AA2699C Bicester Phase 1

Document ref. AA2699C/6.01/100
Rev.0 - 16.06.15 – First Issue

Design Justification for changes to Flat blocks containing plots 302 - 325 & 370 - 375

Extract from Plot 320 - 325 Front Elevation - **AS APPROVED**

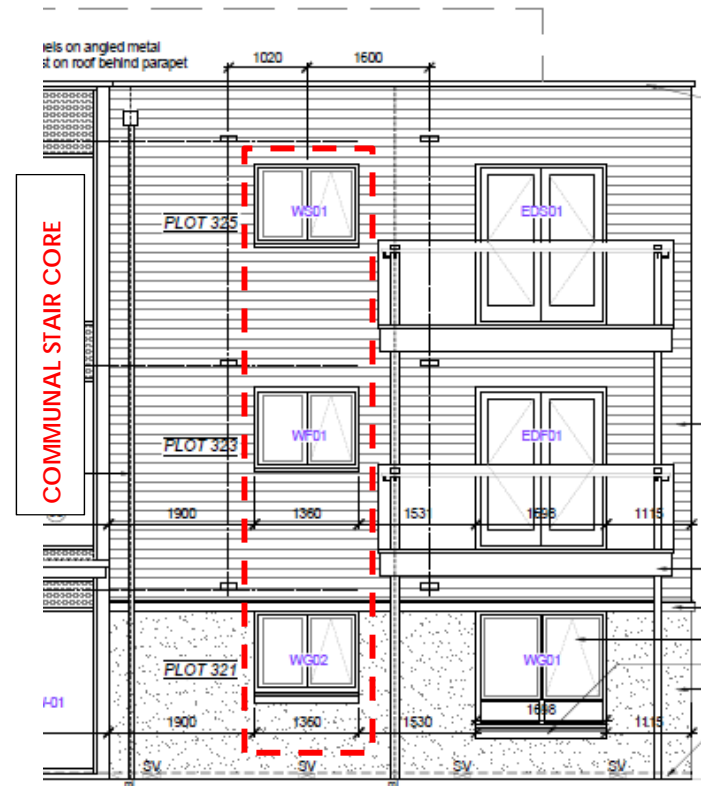
The position of 3no. windows at ground, first and second floor levels (one at each level), have been adjusted to suit the requirements of Approved Document B, which states windows to a dwelling must be a minimum of 1.8m from the unprotected (glazed) area of any communal escape route/stair. This is to prevent the risk of fire in a dwelling jeopardising the escape route.
